TO: Mercedes-Benz Dealer Principals, General Managers, Sales Managers, Service Managers, Parts Managers	FROM: Thomas Brunner, Department Manager, Vehicle Compliance and Analysis, Engineering Services
RE: Service Campaign 2014070001 – Check Engine Cover, Replace if Necessary, MY 2014 ML-Class (166)	DATE: August 1, 2014

Campaign No 2014070001, August 2014

SUBJECT: **Model 166 (ML) AMG, Model Year 2014**
Check Engine Cover, Replace if Necessary

Figure 1

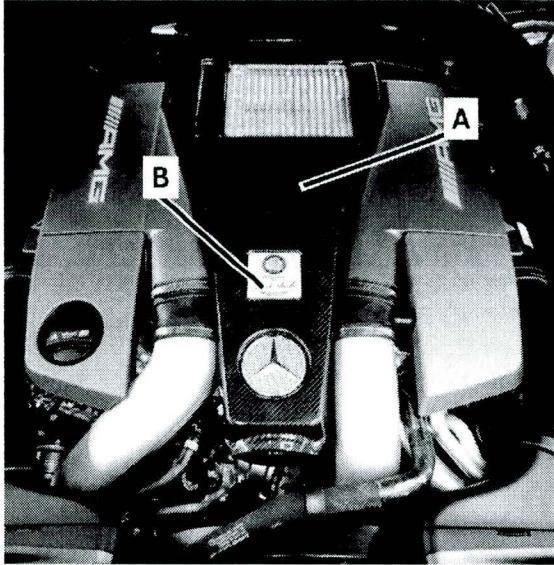
1.  Check engine cover version (A, Figure 1).
 - If Carbon fiber engine cover is installed: Procedure is complete.
 - If plastic engine cover is installed: Replace engine cover. Proceed to steps 2 - 6.

2.  Remove plastic engine cover.
3.  Remove engine plate (B, Figure 1) using a hot air gun and wire or plastic wedge.
4. Thoroughly clean adhesive residue from engine plate (B, Figure 1).
5.  Install engine plate (B, Figure1) on new carbon engine cover (A) using window adhesive (shop supply).

Ensure engine plate (B) is properly oriented on engine cover (A).

6.  Install new carbon fiber engine cover (A, Figure 1).
